October 6, 2008

Re: Parking Structure Evaluation for Parkway Towers Condominium Association
Project No.: 08103

A1. Upper Surface Wear Slab

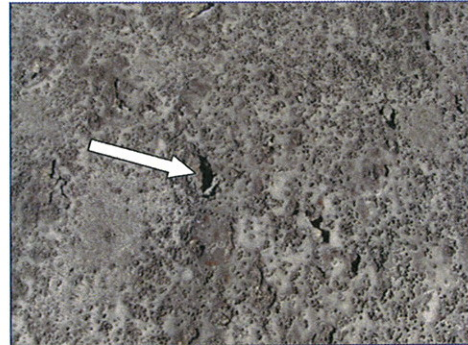
Comments: We observed a significant amount of deterioration of the elastomeric waterproof membrane that has been applied to the concrete wear slab.

We observed a significant amount of concrete deterioration of the upper surface wear slab below the elastomeric waterproof coating. The elastomeric waterproof coating at many locations is easily removed by hand.

We observed approximately 85% of the upper surface of the concrete topping slab to be affected by severe surface deterioration of the elastomeric waterproof coating. As a result of the severe waterproof coating deterioration observed and subsequent concrete topping slab deterioration, we estimate approximately 15% of the concrete topping slab to be sound.

Recommendations: We recommend that the existing waterproof membrane and topping slab be removed. A new topping slab should be poured and a traffic grade overlay system should be installed. These systems provide protection from water intrusion as well as impeding the absorption of deicing salts and deicing compounds. These products are very hard wearing in vehicular traffic conditions. They also provide excellent slip resistance under wet and icy conditions.

A3. Upper Surface Drains

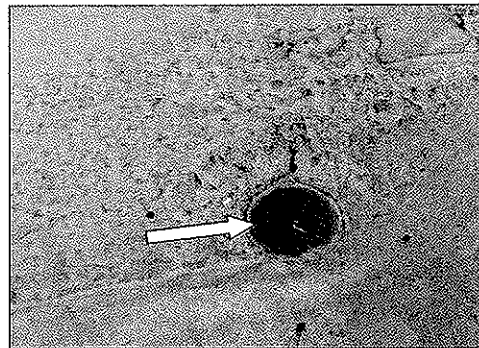
Comments: There were seven deck drains visible during our observations of the upper surface of the parking structure.

The deck drains are located at various locations on the west and south side of the building. The deck drains appear to be functioning properly however; due to the large amounts of runoff from areas to the south and west of the property, the drains appear to be undersized and/or more drains are needed.

Recommendations: The deck drains appear to be undersized or more drains are needed to adequately capture the runoff directed toward the structure. While we did not observe any areas of standing water, the metal screen covers appear to limit the potential flow capability from surface drainage. By increasing the number and size of the drains and modifying the screen covers it will increase the flow potential and reduce the maintenance required to keep the drains functioning at a maximum efficiency.

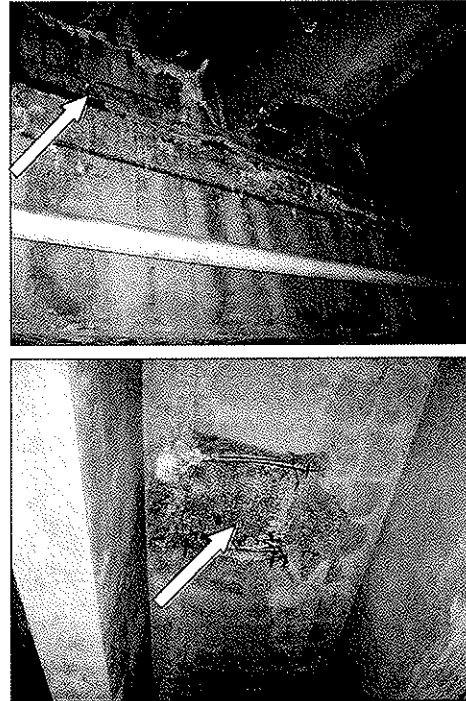
The deck drains drain to an existing storm sewer system which routes the runoff through the building out to public storm sewer located in Ash Street. The condition of this system is currently unknown.

A video scope inspection shall be performed on the existing storm sewer system, at which time Bornengineering can recommend any modification required for the storm sewer system.
